AMENDMENT LIST NUMBER 7 TO
TECHNICAL SPECIFICATION
FOR IGC-APPROVED GNSS FLIGHT RECORDERS

EFFECTIVE 31 DECEMBER 2004
ISSUED BY FAI
ON BEHALF OF THE INTERNATIONAL GLIDING COMMISSION

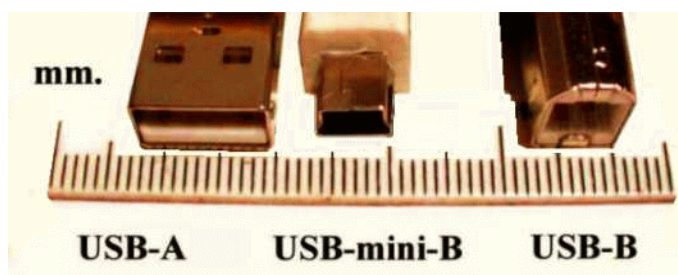
2.7.2.2.7.3 Option 3 - USB connectors. The connector on the recorder case may be a female Universal Serial Bus (USB) B-type receptacle, for connecting the recorder to a PC through a standard USB-B to USB-A cable. Wiring to the connector on the recorder case shall be to the USB standard (see www.usb.org). The recorder port shall be compatible with USB 1.1 and USB 2.0 devices. On the recorder, the receptacle shall be either a full-size USB series B receptacle (for which the male is about 8 x 6mm) or the 5-pin USB series mini-B receptacle for which the male is about 6 x 3mm with angled ends. See the photo that follows. (AL7)
